INDESIT company

Model type:
LL65EU

Commercial code:
F029547

Notices

N1045072FIG1

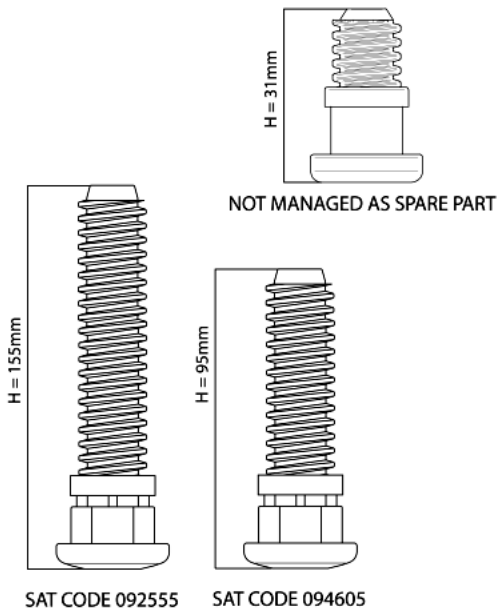
N1045072: Introduction of fixed rear foot H=31mm on free-standing models.

From serial no. 40218.0001, free-standing dishwashers affected by this modification have been equipped with new fixed rear feet (H=31mm).
The new foot replaces the adjustable one (H=155mm) Service code 092555; on the EVO3 range with TurboDry the new foot replaces the adjustable foot (H=95mm) Service code 094605.
The Spare Part Warehouse will continue to manage only 155mm and 95mm adjustable feet as they are interchangeable with the fixed 31mm foot.
The three feet are shown in illustration N1045072FIG1.

N1045069FIG1

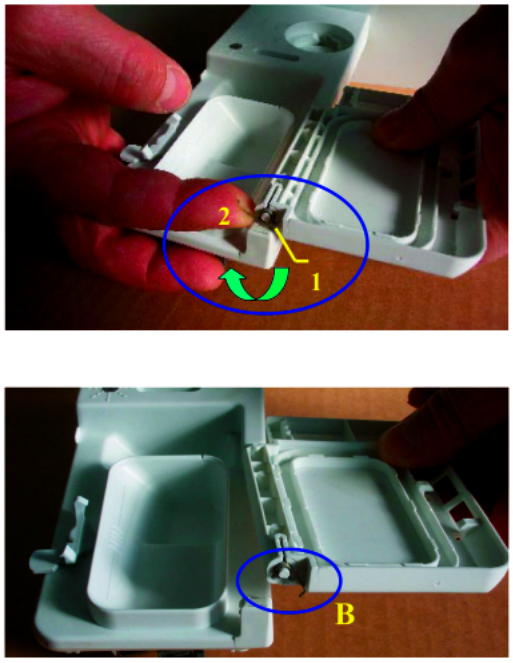
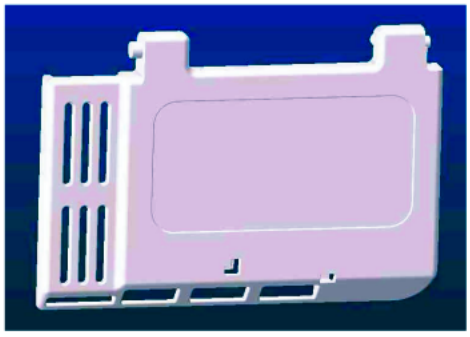
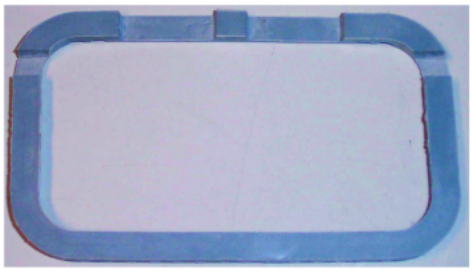
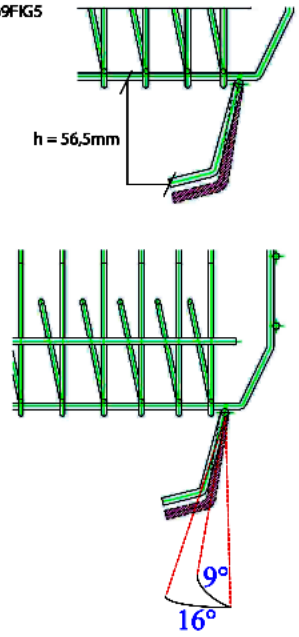
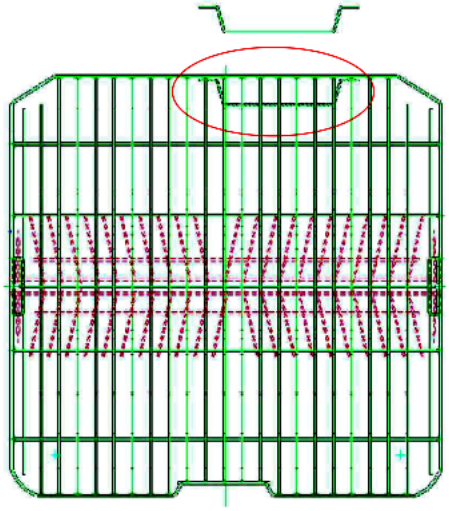
n1045069: Modification of racks and dispenser lid on EVO3 dishwashers

To obtain better dissolving of the detergent during the wash cycle, the following modifications have been made to EVO3 dishwashers:
- new dispenser lid, replacement code 098134 (see figure N1045069FIG4) created;
- upper racks modified with lid catch angle changed from 9° to 16° (see figure N1045069FIG5);
- MultiSystem lower racks modified with insertion of a spacer wire at the electric dispenser (see figure N1045069FIG6).

Lid installation instructions:
1) prise the lid out of the dispenser seat using a small screwdriver at point A (figure N1045069FIG1);
2) replace the lid, checking that release spring B (figure N1045069FIG2) is in place; before fitting the new lid load the spring from position 1 to position 2 (figure N1045069FIG2);
3) fit the lid in its special seat and check for correct operation (figure N1045069FIG3).
Lid closing may be harder for the first few cycles after replacement, due to settling of the material.

The upper and lower racks have the same spare part codes as the premodification items; Replacements Warehouse stocks have been replaced.

N1045075FIG1

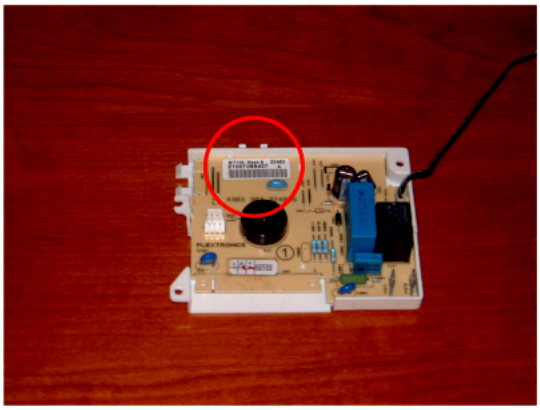
n1045075: Unification of Timer BIT 100 Service codes 097431 and 095281 with 097481.

BIT 100 "P2" TIMER (210097637.XX) Service code 097431 has been replaced with BIT 100 "E2" TIMER (210097877.02) Service code 097481.
BIT 100 "D" TIMER (210093806.XX) Service code 095281 has been replaced with BIT 100 "E2" TIMER (210097877.02) Service code 097481.

Replacement of Service codes 097431 and 095281 with 097481 is only possible with BIT 100 "E2" TIMER card code 210097877.02.

The card code is printed on an adhesive label located on the box or on the card itself (illustration N1045075FIG1).

Possible 210097877.XX card spares with modification index below 02 cannot be used for replacing, but can be used on the relevant INDESIT models (giving the BIT 100 "E2" TIMER Service code 097481 in the spare part list) until stocks last.

Stocks of Service code 097481 in the Spare Part Warehouse have been replaced with card 210097877.02.

N1045083FIG1

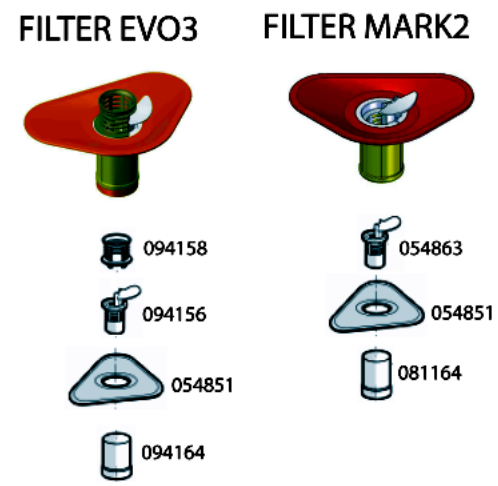
n1045083: Modification of filters on EVO3 60 cm dishwashers

All dishwasher models affected by this modification have been equipped with the items listed below, in order to solve the drain pump clooging problem.

Introduction of:
Cylindrical plastic filter code 081164
Central filter code 054863

Elimination of:
Cylindrical plastic filter code 094164
Central filter code 094156
Central filter grid code 094158

The modification has been introduced progressively, starting from serial no. 40516.0001.

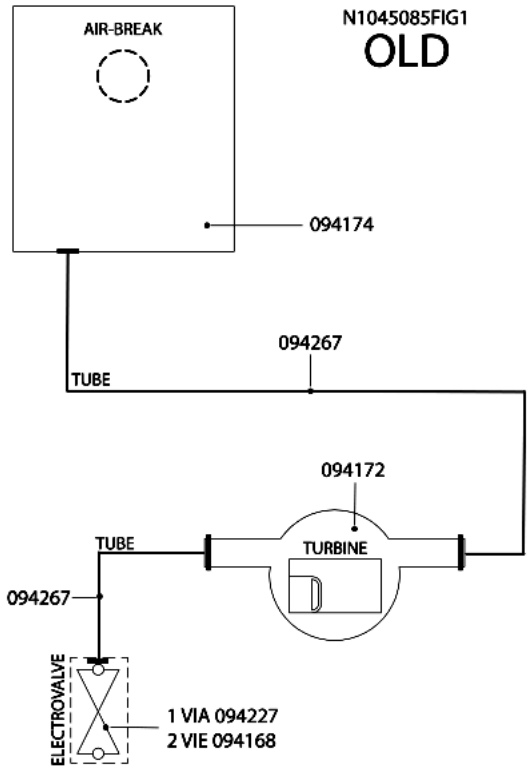
n1045085: Introduction of new litre counter turbine integrated on air-break.

All dishwashers affected by this note have been equipped with a new litre counter turbine on the air-break.

Picture N1045085FIG1 illustrates the premodification structure, picture N1045085FIG2 the new structure.

AIR-BREAK:
new 110610;
premodification 094174;
the new item features a new integrated litre counter turbine and its water supply hose has a smaller diameter.

LITRE COUNTER TURBINE code 094172 has been eliminated.

SOLENOID VALVES:
new:
1-WAY code 110611;
2-WAY code 084558(Rohs 143737);
premodification:
1-WAY code 094227;
2-WAY code 094168;
the new solenoid valves have a smaller diameter drain hose fitting.

HOSES:
new solenoid valve hose/air-break code 110612;
premodification turbine hose/air-break code 094267;
premodification solenoid valve hose/air-break code 094267;
the new hose has a smaller internal diameter.

WIRING:
the litre counter turbine connecting cable is longer, but since the connector is the same, the new item can be used in place of the premodification one.

N1045093FIG1
NEW FLAP UPPER BASKET SAT CODE 114799

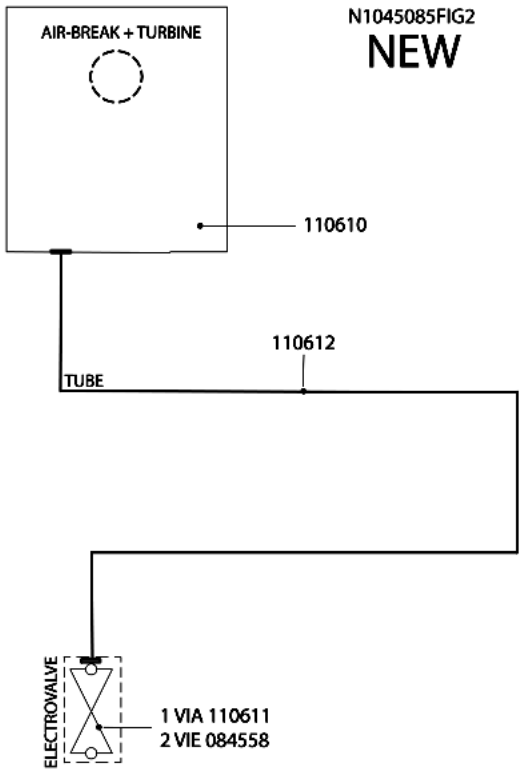
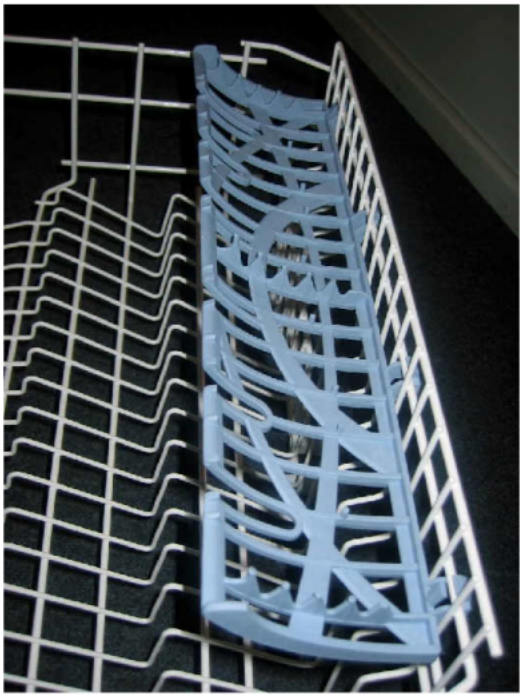
n1045093: Modification of light blue folding shelf attachment.

From serial no. 41109.0001 all models affected by this bulletin feature a modification of the folding shelf to upper basket coupling system.
This modification called for alteration of the relative baskets: the distance between the wire on which the folding shelf is attached and the wire below it has been increased from 9.5 mm to 17 mm, as shown in the attached image.
The altered folding shelves are not interchangeable and cannot be installed on premodification baskets: in the case of service interventions on product with serial number prior to 41109.0001 the entire upper basket must be replaced.
The baskets are reciprocally interchangeable and are managed as assemblies complete with their accessories, inclusive of folding shelves.

UPPER BASKET LIGHT BLUE FOLDING SHELF
new 114799 - premodification 094140.

UPPER BASKET ASSEMBLIES
new 115001 - premodification 094139;
new 115002 - premodification 094222;
new 115003 - premodification 094233.

N1045076FIG1

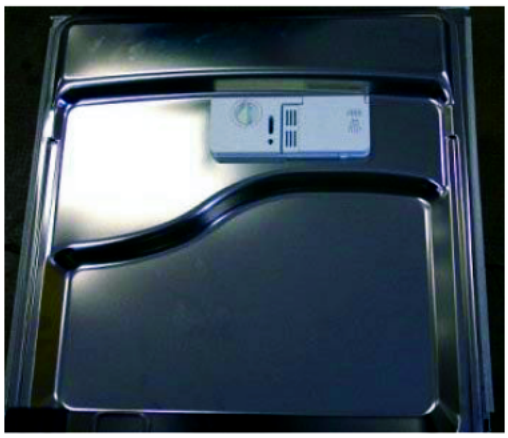
n1045110: Different position of electric distributor.

The position of the electric distributor has been changed as shown in the attached illustration.
The new machines have a new industrial code.

Introduced items:
C00118141 upper rack
C00108981 inside door
C00109858 internal door sound-proofing panel
C00109857 internal door spacer

Premodification items:
C00115002 upper rack
C00094695 inside door
C00094184 internal door sound-proofing panel
C00094147 internal door spacer

Cod. 16001695900

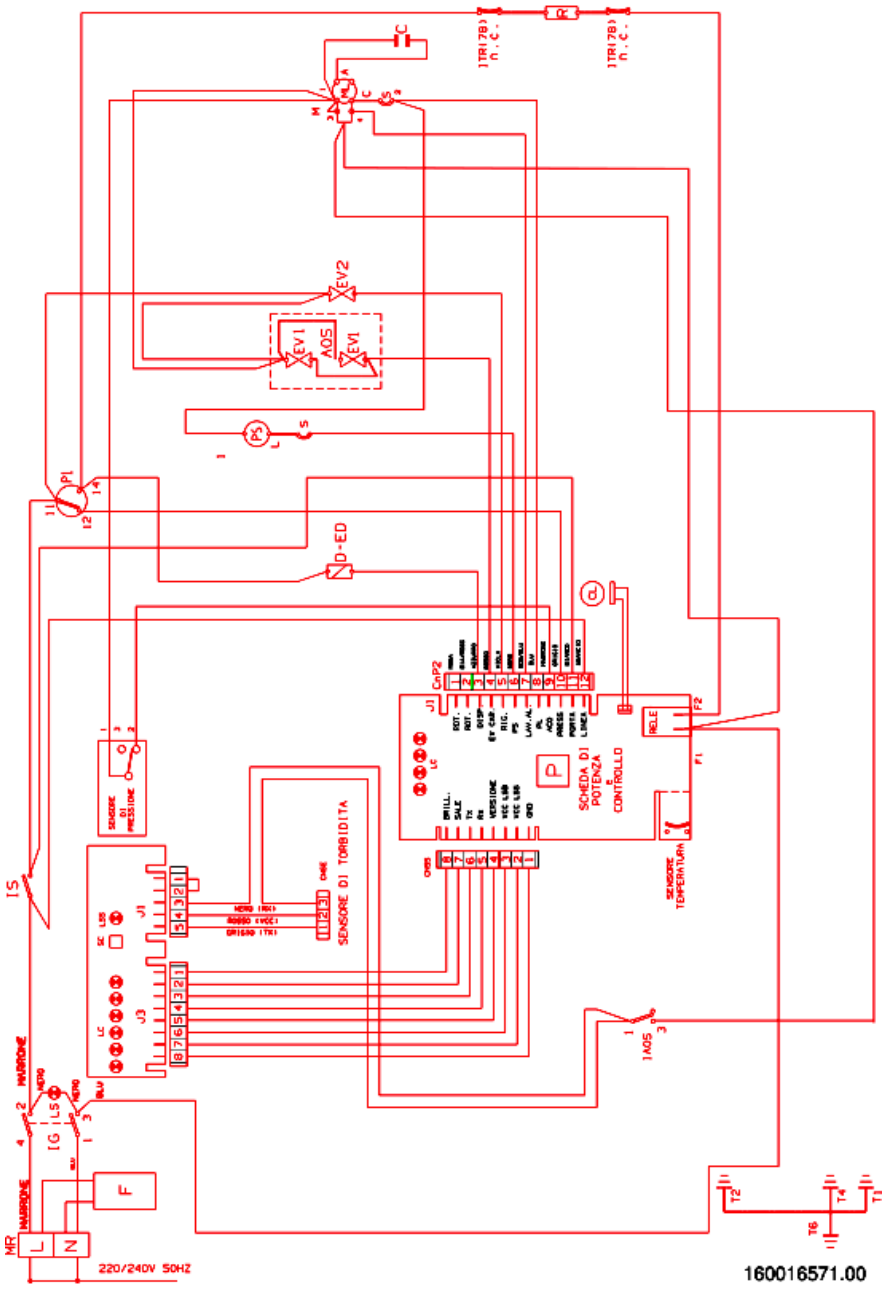
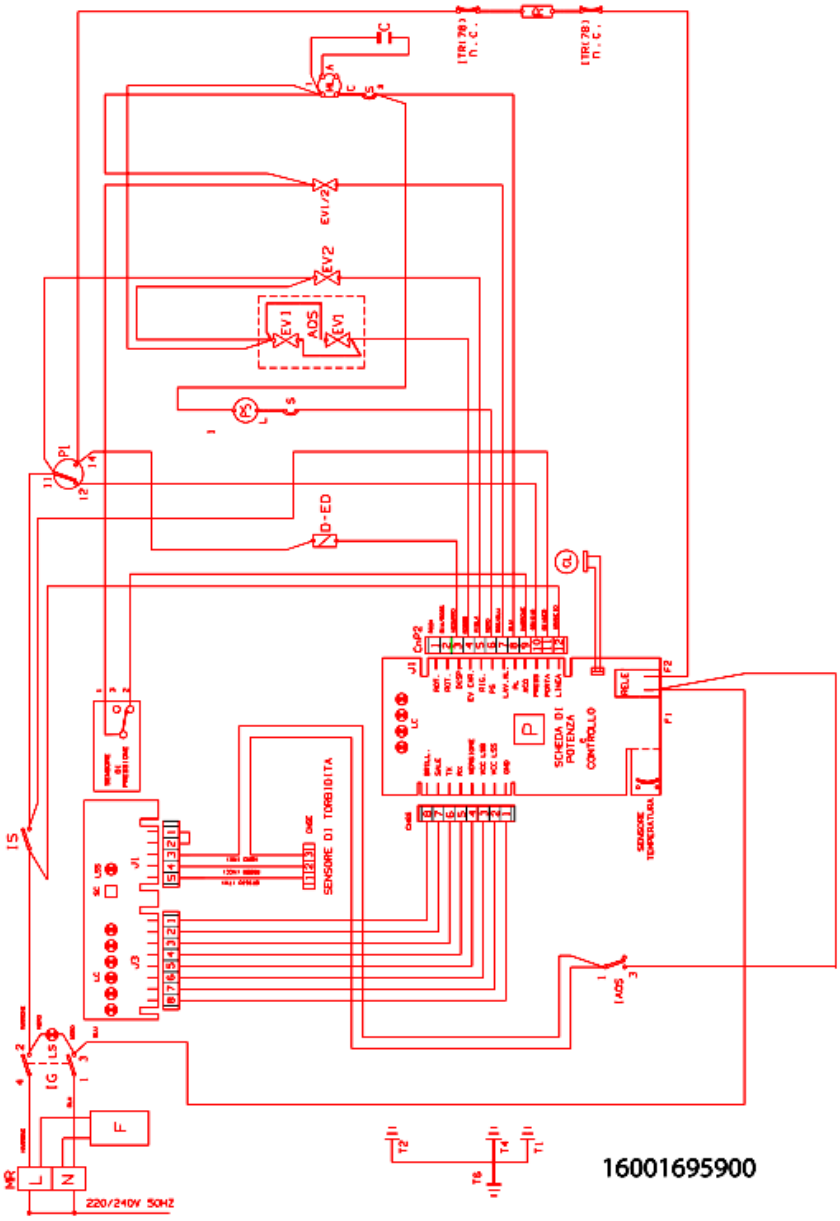
n1045070: Introduction of 1/2 load control with BIT 100 timer by means of solenoid valve.

EVO3 dishwasher models affected by this modification have been equipped with the new BIT 100 timer, in place of the alternating wash motor, that controls the 1/2 load system by means of a solenoid valve located on the volute of the electric pump.
Modified items:
- electric pump code 088896(W45V220P20) replaced with 077140(W75V220P24);
- electric pump code 088888(W45V240P20) replaced with 080512(W75V240P24);
- volute code 088889 replaced with 054979;

- BIT 100 timer code 094686 replaced with 097431;
- alternating wash motor code 077172 replaced with half load solenoid valve code 054985.

LL65EU Commercial Code 29547 Serial no. 31027.0001 ;
Wiring: new 098829 premodification 095933 ;
Wiring diagram: new 16001695900 premodification 16001657100.

Cod. 16001741100

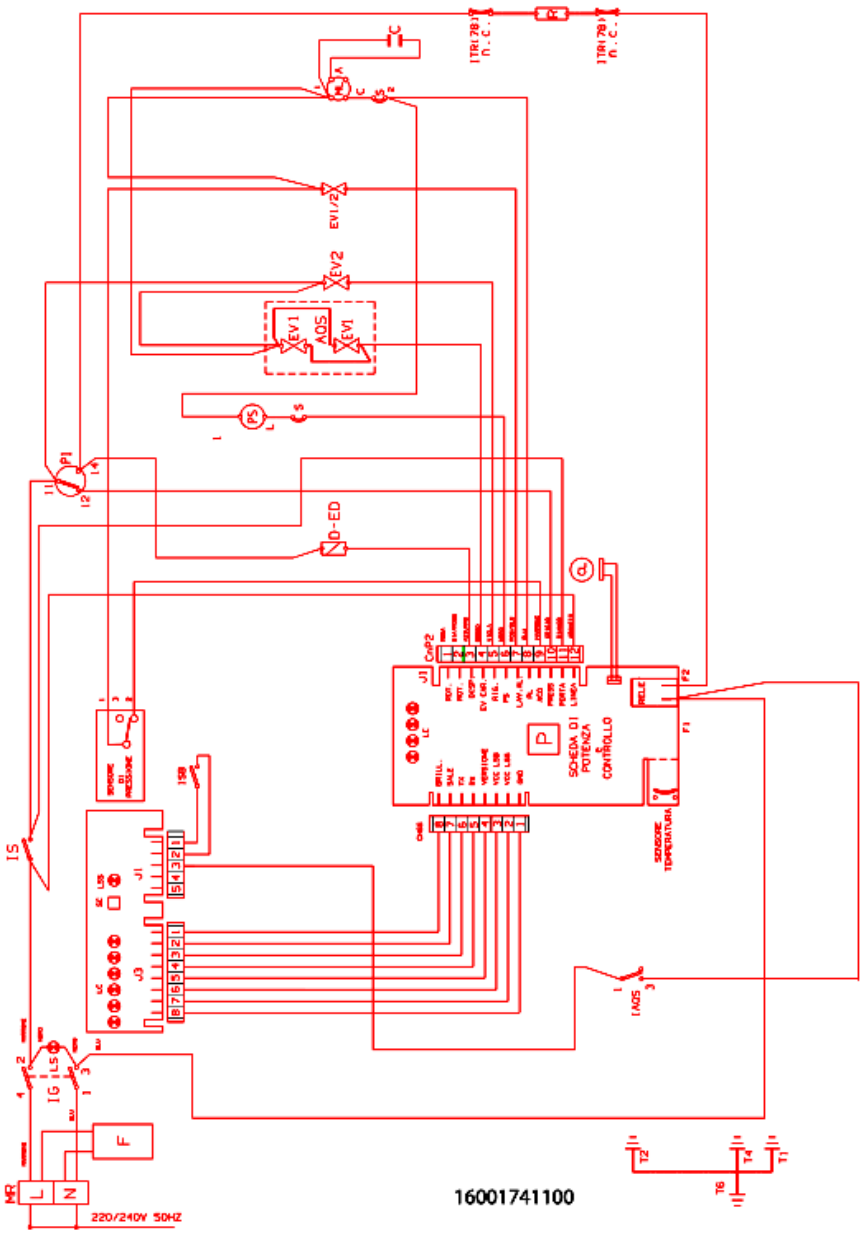
n1045071: Elimination of turbidity sensor code 091523 on EVO3 Dishwashers.

From serial no. 40107.0001, the turbidity sensor spare part code 091523(Rohs 143577) has been eliminated from EVO3 dishwashers affected by this note.

This modification also concerns the timer BIT100 code 097481 (rohs 143207) that replaces 097431, the reed electric dispenser code 097874(Rohs 143801) in place of 094133(Rohs 143377), and new wiring/wiring diagrams.

LL65XEU (commercial code 29910)
LL65EU (commercial code 29547)
Wiring: new 098981 - premodification 098829
Wiring diagram: new 16001741100 - premodification 16001695900
